23-4D-3090 LMDR

23-4D-2080 T3NE.WL
23-4D-2090 T3NE
23-4D-2100 T3N.DS
23-4D-2110 T3N.IS

Cross-Section

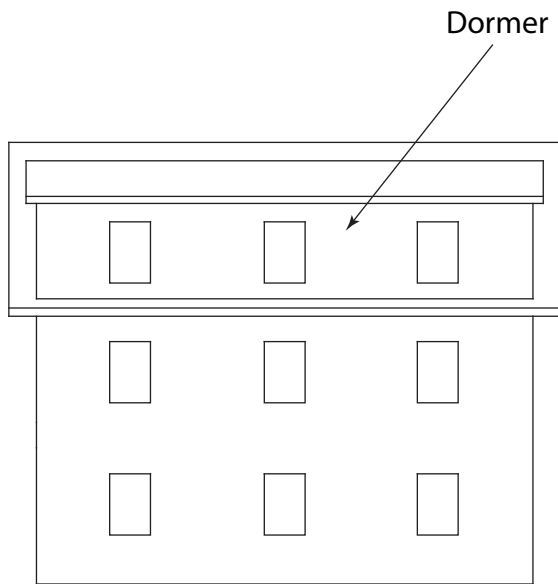
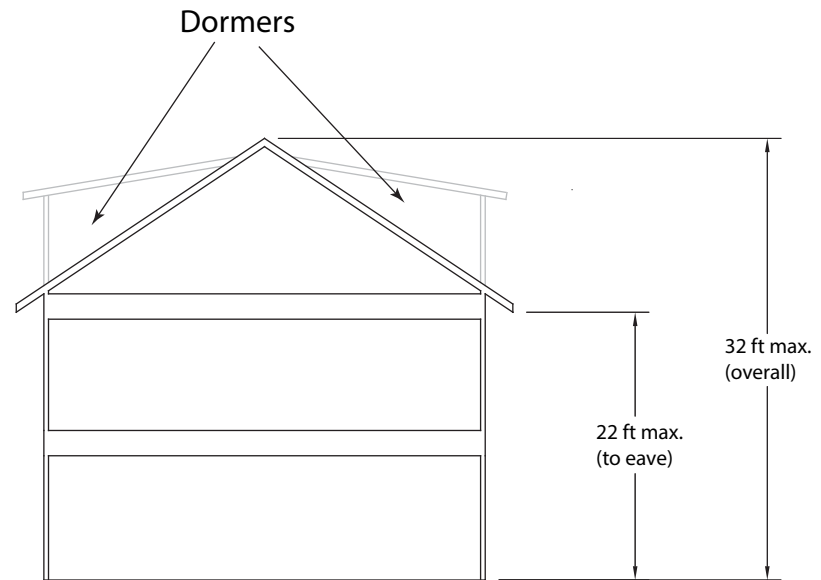
What is the definition of a “story”? Does an attic count as “story”? Since there are no apparent restrictions on length or slope of attic dormers in T3 and if an attic is not defined as a “story”, one could build a small perimeter gable “roof” around what would otherwise be essentially a third floor and call it an attic, circumventing the two-story requirement (see attached diagram).

ATTIC IS ESSENTIALLY A THIRD FLOOR
WITH NO FAR LIMITATIONS AND NO TENT REQUIREMENTS IN T3, HOUSES COULD BE MASSIVE
IF THERE ARE NO LIMITATIONS ON ATTIC DORMERS
